KNOXVILLE/KNOX COUNTY METROPOLITAN PLANNING COMMISSION SUBDIVISION REPORT - CONCEPT/USE ON REVIEW

► FILE #: 5-SC-16-C AGENDA ITEM #: 8

► SUBDIVISION: EDITH'S PLACE

► APPLICANT/DEVELOPER: TEKCO, LLC

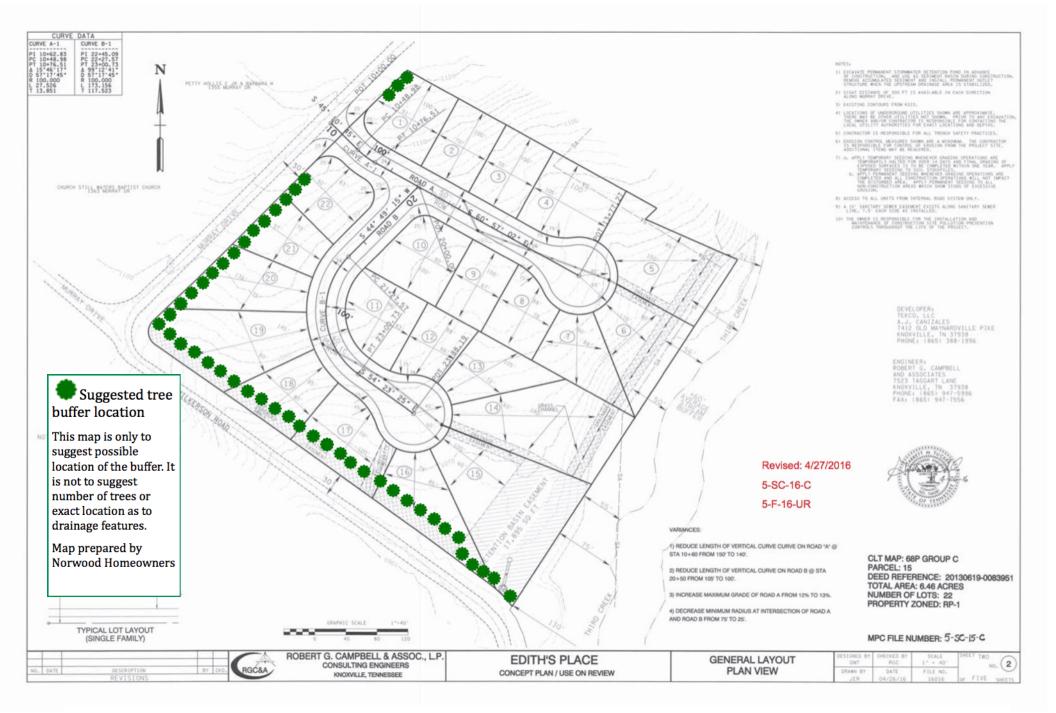
The solution is to place a barrier between the back yards and the roadways. A masonry wall or a board fence is too expensive for the small number of houses in this subdivision.

A much better solution is to install a landscape barrier of cypress trees that will grow together along Wilkerson and part of Murray. (Perhaps: Thuja Green Giant Arborvitae or Spartan Juniper - Juniper chinensis 'Spartan' (Cupressaceae Juniperus Spartan))

These trees can be planted in a small size and will grow together to block the view the headlights and the noise.

- 5. Note that on the attached PDF the green barrier does not go right up to the entrance of the subdivision. It pulls back on the first 2 lots at the entrance to give the developer the freedom to make his entrance to his development look good.

- 7. Provide landscape screening along the Murray Drive and Wilkerson Road frontages, consisting of existing mature trees and new evergreen trees, consistent with the intent of the attached landscape buffer plan. The landscape screening is to be approved by MPC staff before design plan approval by City Engineering.
